Far East Knitting & Dyeing Industries Ltd (Extension 2)

Chandona, Thana-Kaliakoir, Gazipur

15 January 2024

2. Observations:

Table 3.1
Far East Yarn Dyeing

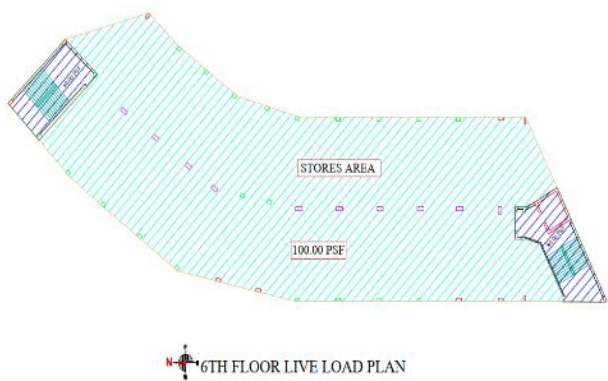
Observation: Inconsistency in design report (Building-28).

Description: Equivalent concrete strength is considered as 24.72 MPa (3585 psi) for all structural members based on the concrete core test report of the MAT foundation. The building engineer is required to check the column capacity based on in-situ concrete strength and update the design report.

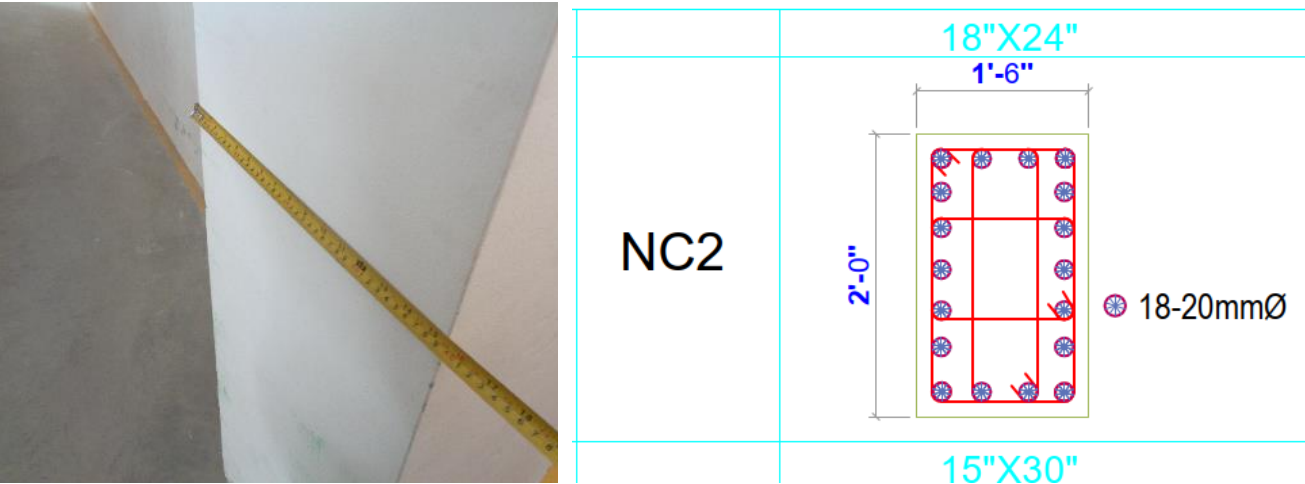
Observation: Load plan doesn't comply with BNBC (Building-28)

Description: Live load for storage area is considered as 5 kPa at several floors but as per BNBC-2006 live load for storage areas is required to be considered as 6 kPa (minimum). The building engineer is required to revise the load plan as per BNBC requirements and check the design accordingly.

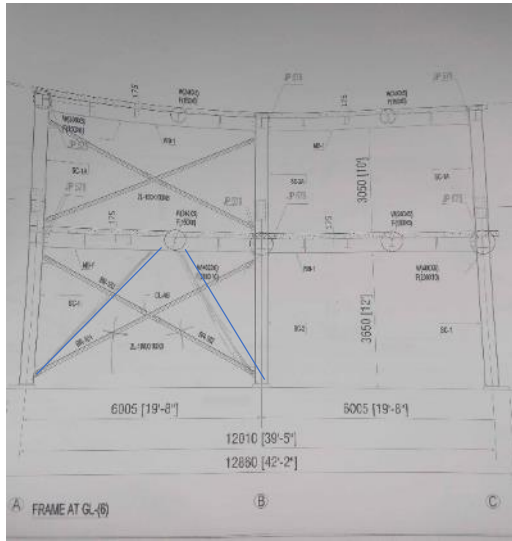
Observation: Discrepancy in as-built drawing (Building-28)

Description: The dimension of column NC2 was measured as 500 mm X 350 mm instead of 600mm X 450 mm on the 2nd floor. The building engineer is required to update the as-built drawing.

Mismatch in column size at column schedule

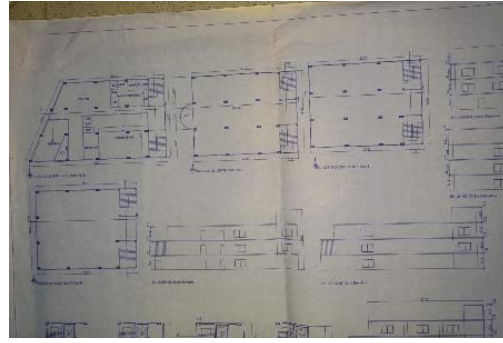
Observation: Mismatch in as-built drawings. (Building-3)

Description: In the as-built structural drawing, the C1 and C2 column sizes don't match with on-site conditions. In the drawing, C1 and C2 column sizes are shown as 400X800 whereas C1 and C2 column sizes were found 400X600 and 400X575 respectively on-site.

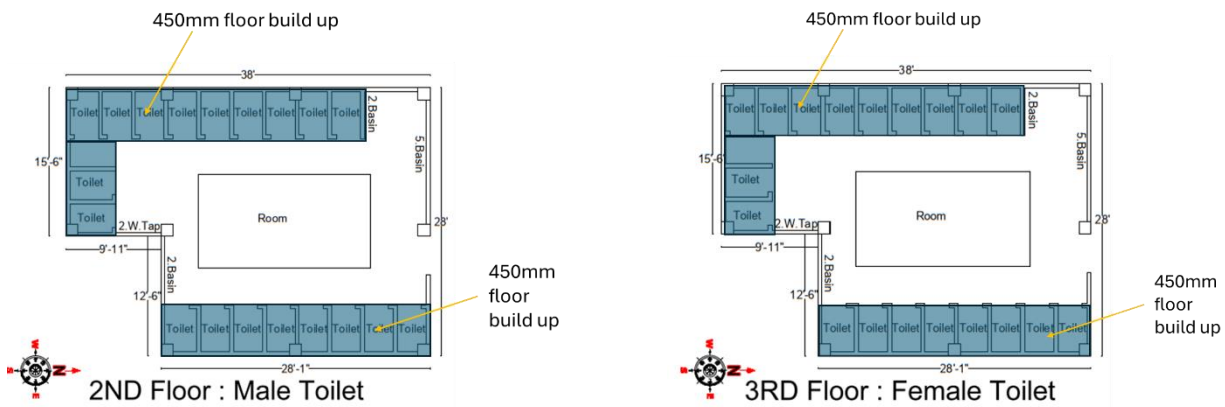
Observation: Possible falling hazard (Building-3)

Description: During inspection, the railing was found missing at some locations on the roof and the stairs. The factory is required to provide railing to prevent probable falling hazards.
